RE: Comments on the draft revision of Caloosahatchee MFL dated July 2017.

Thank you for the opportunity to comment on the July 2017 TECHNICAL DOCUMENT TO SUPPORT REEVALUATION OF THE MINIMUM FLOW CRITERIA FOR THE CALOOSAHATCHEE RIVER ESTUARY.

Figure 1. Salinity / flow relationship in the Caloosahatchee estuary.

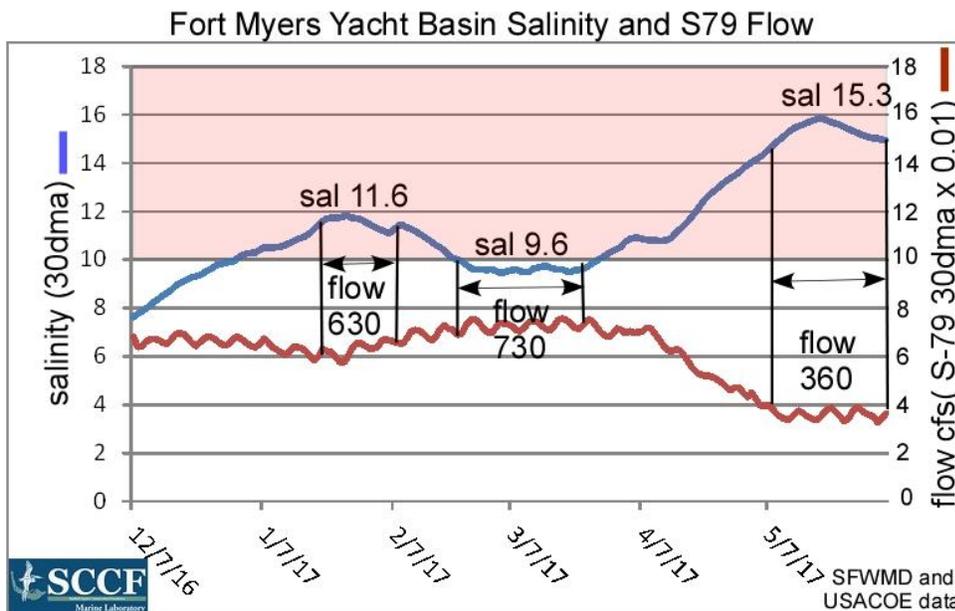
An assessment of the flow / salinity relationship by staff at the Sanibel Captiva Conservation Foundation clearly demonstrates that a flow as high as 600 cfs at S-79 during a 30 day period is inadequate to meet the 10 psu maximum for *V. americana* (Fig. 1). This assessment did not include the tidal basin flows to the estuary, which would have likely added additional flow above 600 cfs.
